Planning Application (part retrospective) **261414** at 28 Milton Road

Retrospective Application to take into account changes from Approved application 241588 and subsequent Refused application 252476.

Objection from ACER, The Whitegates Residents Association

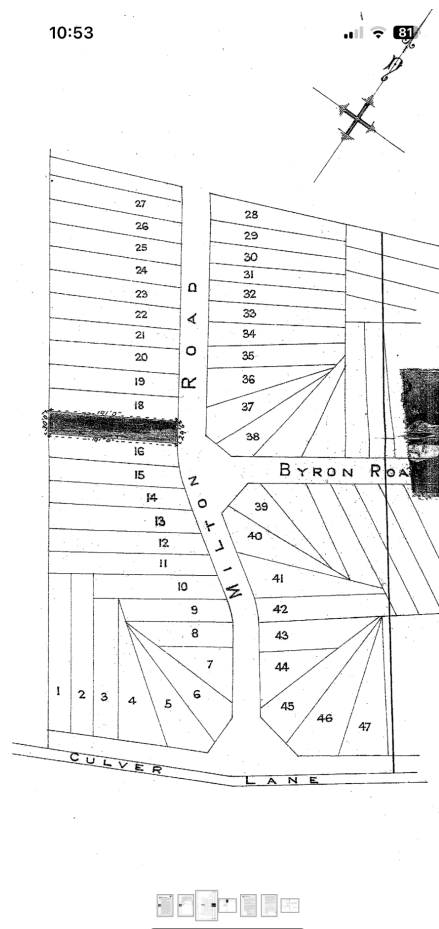
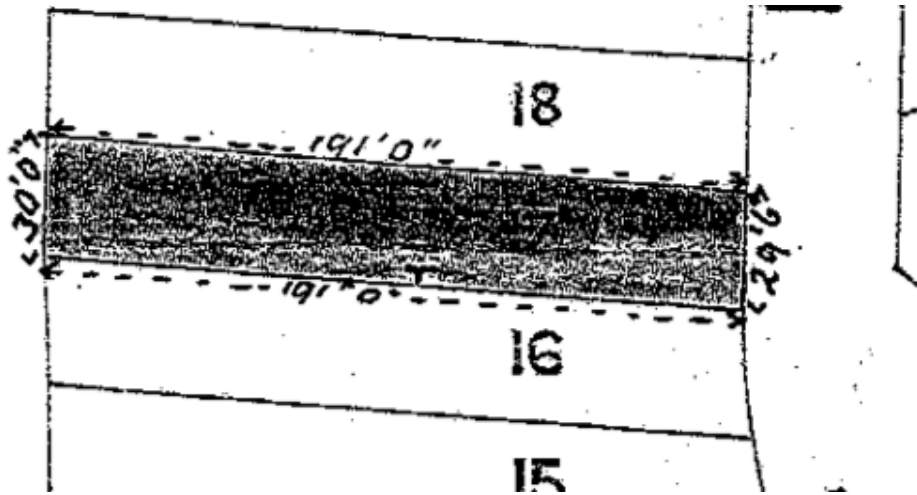
Subsequent to the latest Refusal, ACER has received evidence showing:

Land Registry plan (below) shows the width of the frontage of no 26 (built on plot 17) to be 29 feet 6 inches wide.

The Land Registry Plan shows the width of the rear boundary to be 30 feet wide, exactly where a shed build by the previous owner of 28 still stands

No 28 had permission to build a side extension 800mm from the boundary with no. 26. This side extension as built does in fact cross the straight boundary line shown on the land registry documents. The distance across the land at 26 to the extension of 28 is 28 feet 10 inches. It should be at least 29 feet 6 inches to the boundary. **This places the ground floor side extension of 28 at least 8 inches inside the boundary of the neighbouring property at 26.** Certainly; the inset second floor side extension is not 800mm from the boundary as approved. The new side extension at 28 is therefore too wide to fit on their land according to Land Registry documentation.
